CITY OF NOVI CITY COUNCIL
AUGUST 31, 2020

SUBJECT: Consideration for Final approval of the request of BC Novaplex, LLC, for Novaplex, JZ19-37, with Zoning Map Amendment 18.733 to rezone from OST, Office Service Technology to RM-2, High-Density Multiple Family Residential under the Planned Rezoning Overlay (PRO) process on land located on the west side of Haggerty Road, north of Twelve Mile Road in Section 12, together with approval of the PRO Plan and PRO Agreement. The applicant is proposing to develop a 272-unit multiple-family residential development on approximately 22 acres of land.

PRO CONCEPT PLAN
(4th Revision)
July 30, 2020

NOVAPLEX

ORIGINAL ISSUE DATE:
 JULY 26, 2019
 PEA JOB NO. 2015-296
 SCALE: 1" = 50'
 DRAWING NUMBER:
C-2.3

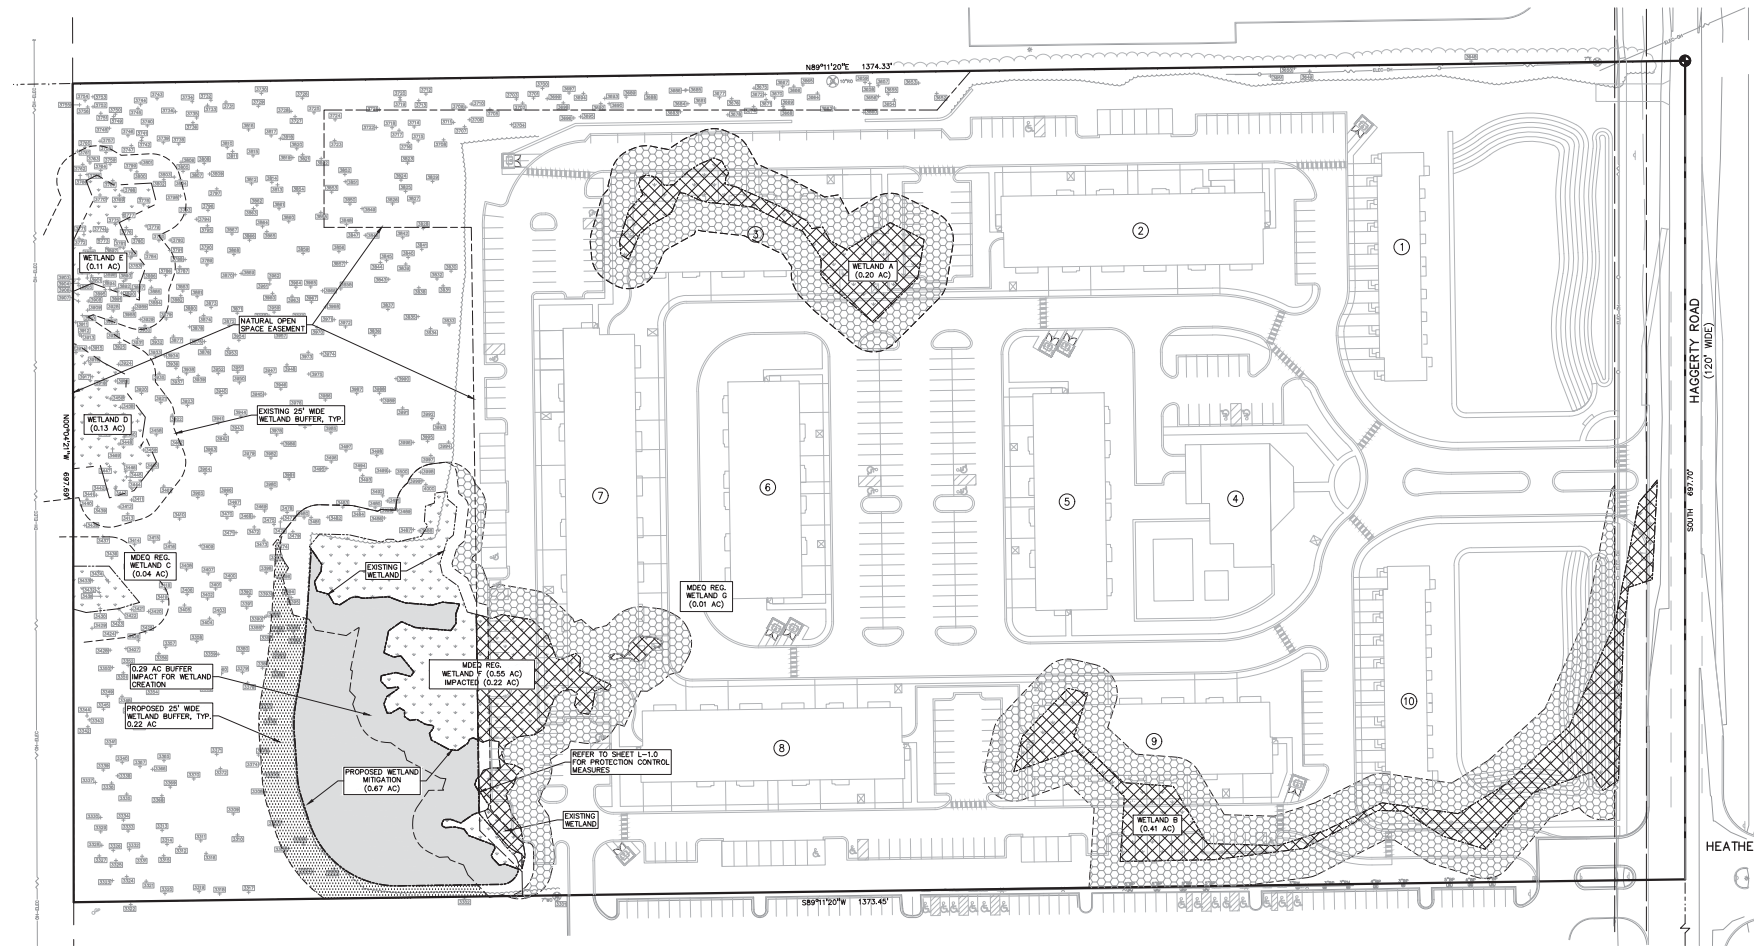
6. Wetland Mitigation: The applicant has not indicated any additional wetland mitigation will be accommodated on the subject site. A note has been added to sheet C-2.3 that indicates the 0.59 acres would be "Proposed off-site/Wetland Bank OR Pay into City Fund." **Staff notes that the ordinance intent is for mitigation to be provided within the City. The applicant has indicated they understand the City does not have a fund established to create or maintain wetland banks, and is exploring options to construct the mitigation on other sites in the City.**

The Plan indicates seven (7) areas of existing wetland on the development site (Sheet C-2.3; *Wetland Impact Plan*). The Plan currently proposes impacts to four (4) of these wetlands (i.e., Wetlands A, B, F, and G). Wetlands C, D, and E are proposed to be preserved. It should be noted that the current Plan does not appear to indicate and quantify the proposed impacts to the existing 25-foot wetland setbacks. A description of the apparent wetland impacts follows. The following table (Table 1) summarizes the existing wetlands and the proposed wetland impacts:

ORIGINAL ISSUE DATE:
 JULY 26, 2019
 PEA JOB NO. 2015-298
 DRAWING NUMBER:
C-7.0

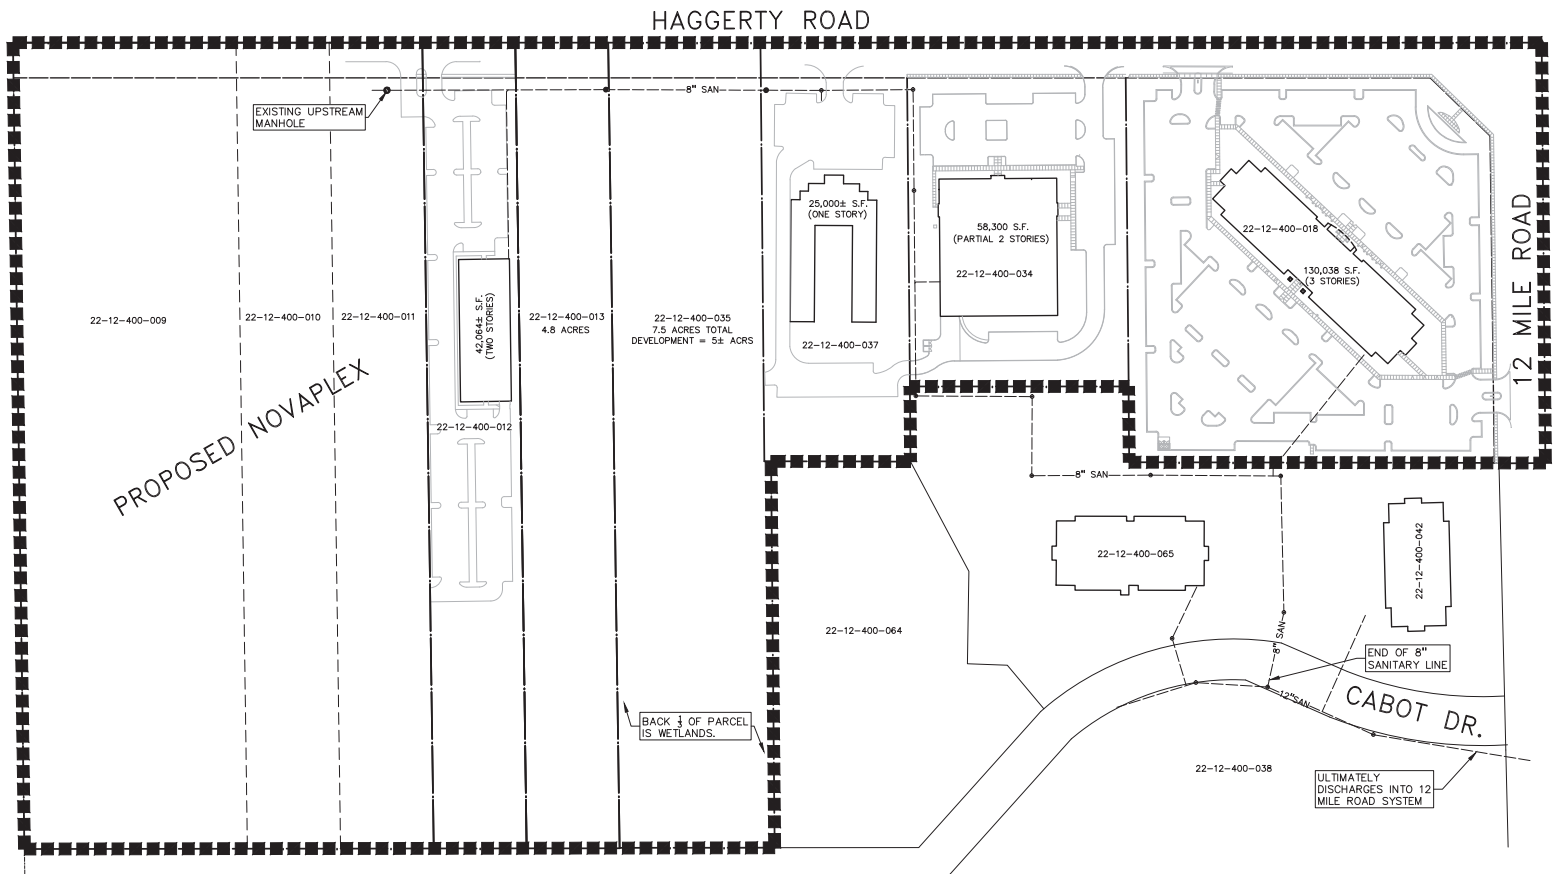
9. **Sheet C-7.0 has demonstrated the existing 8-inch sanitary sewer is projected to have sufficient capacity for the added flow from the site, as proposed in this concept.**
10. Provide a sanitary sewer monitoring manhole, unique to the clubhouse, within a dedicated access easement or within the road right-of-way. If not in the right-of-way, provide a 20-foot wide access easement to the monitoring manhole from the right-of-way (rather than a public sanitary sewer easement).
11. Sanitary leads shall be buried at least 5 feet deep where under the influence of pavement.
12. The sanitary sewer basis of design has been revised to show the breakdown of number of bedrooms per apartment. Additionally, the REUs per apartment reflect the "Residences: Mobile Home Parks & Multiple Family Residences" Usage Type for one, two, or three or more bedrooms on the City of Novi Sewer Unit Factor Chart.

PROPOSED SIDEWALK GAP IMPROVEMENTS

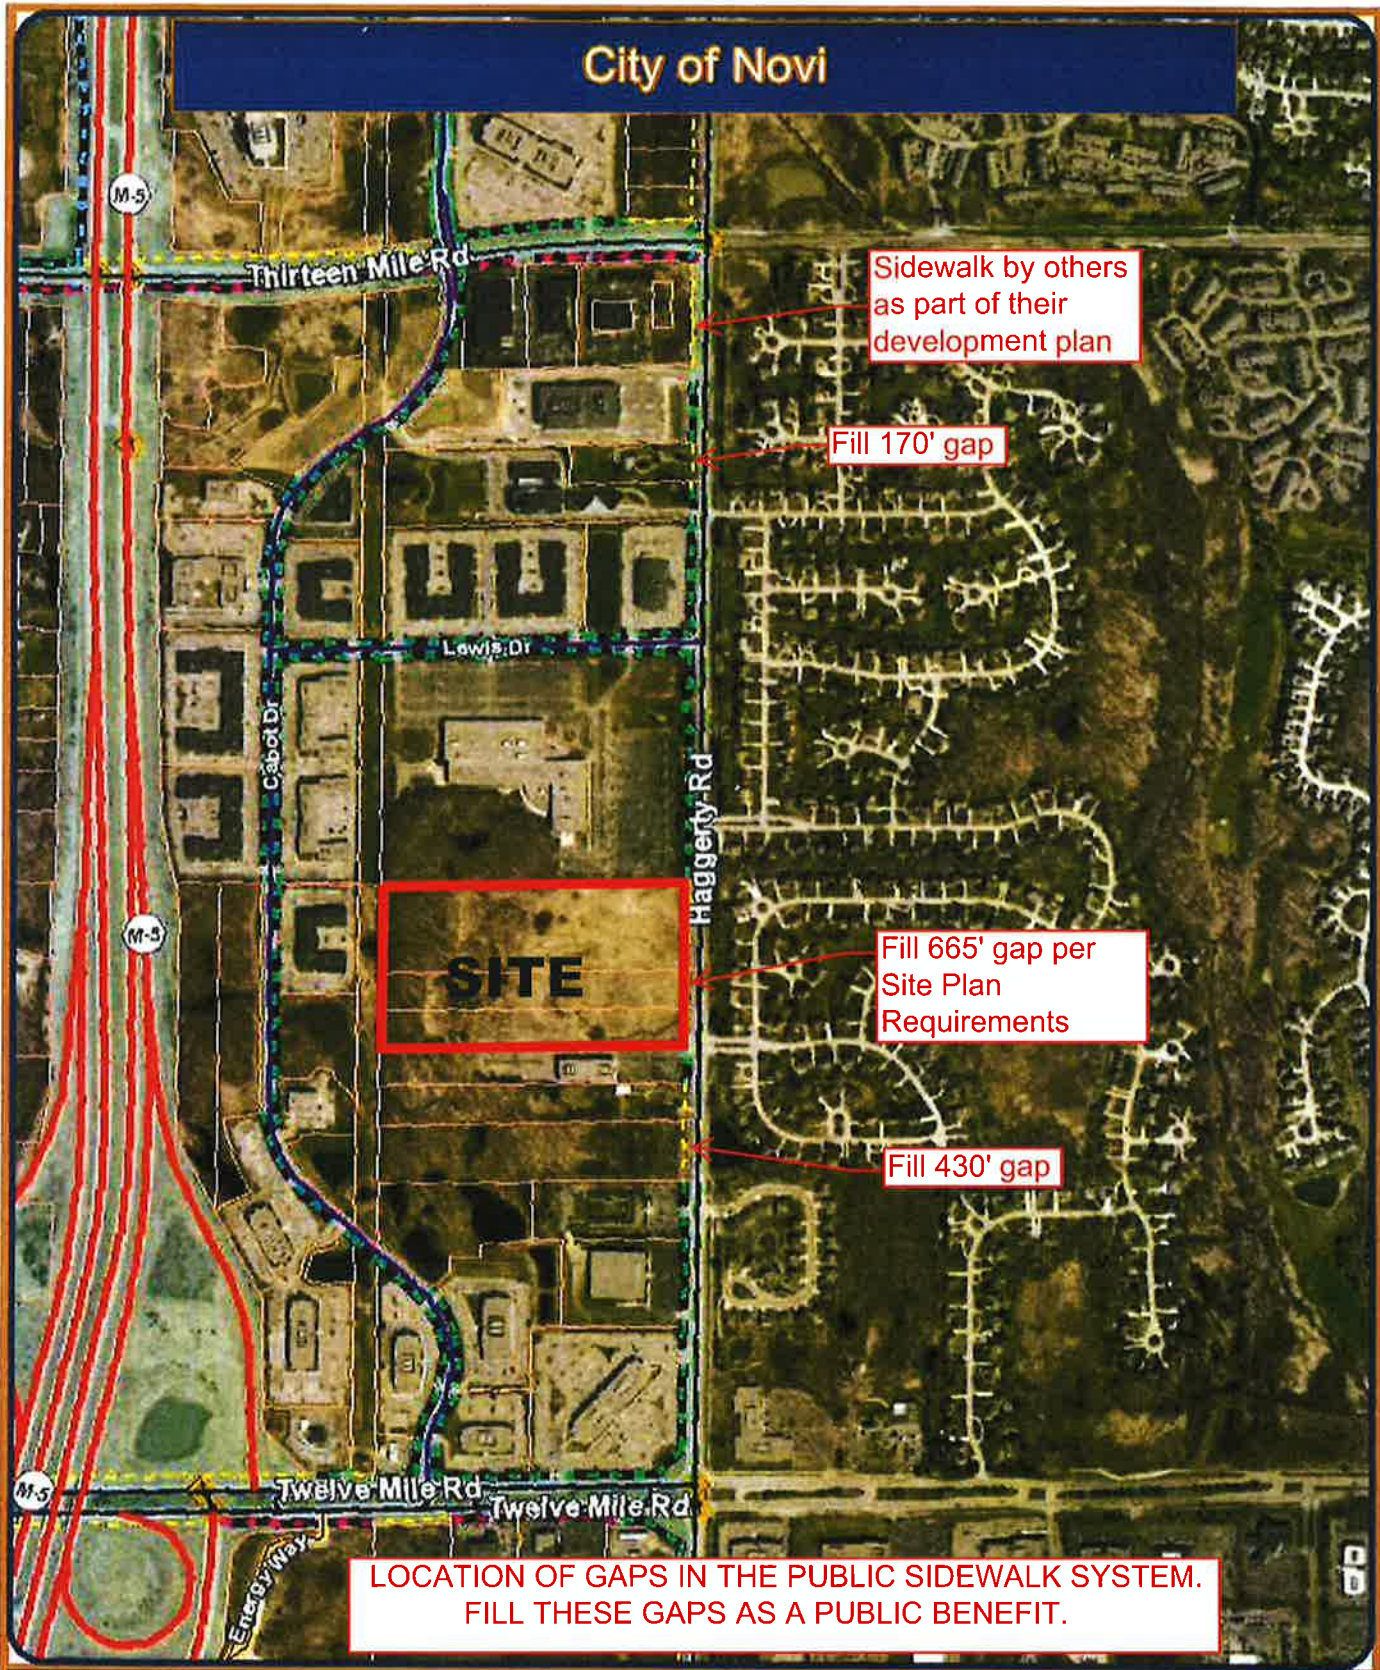
7. Off-Site Sidewalk Benefit: **The applicant has been asked to provide a sheet within the PRO Concept Plan that shows the two off-site sidewalk segments they have offered to build as a public benefit. The packet includes a place-holder to show the locations, which will be replaced with a full plan sheet prior to recording the PRO Agreement.**

Figure 1. City of Novi Regulated Wetland & Woodland Map (approximate project property boundary shown in red). Regulated Woodland areas are shown in green and Regulated Wetland areas are shown in blue.

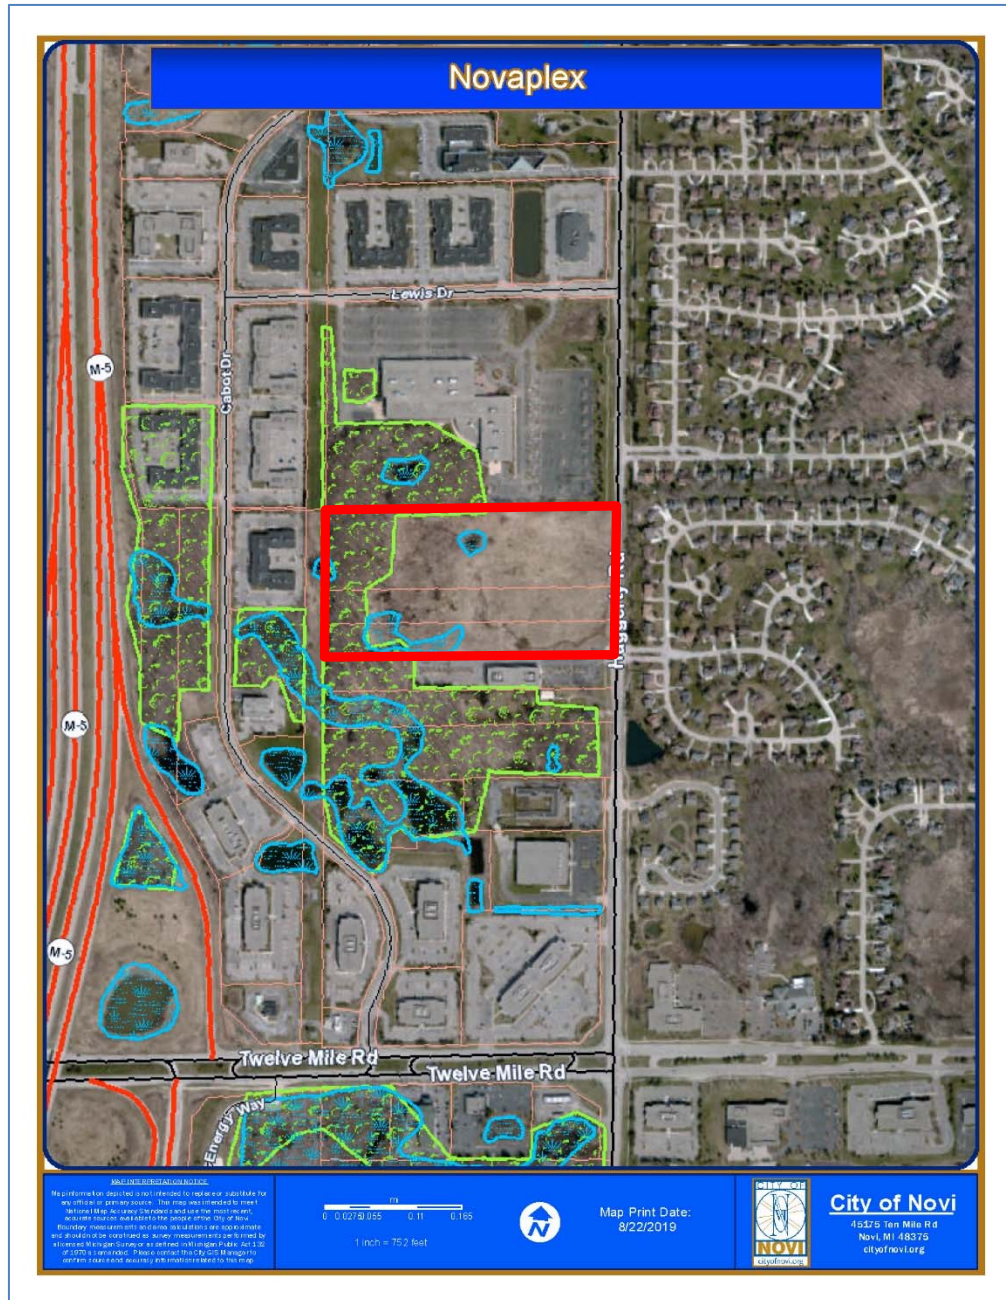
ECT’s in-office review of available materials included the City of Novi Regulated Wetland and Woodland map, USGS topographic quadrangle map, NRCS soils map, USFWS National Wetland Inventory map, and historical aerial photographs. The site includes areas indicated as City-regulated wetland on the official City of Novi Regulated Wetland and Woodland Map (see Figure 1).
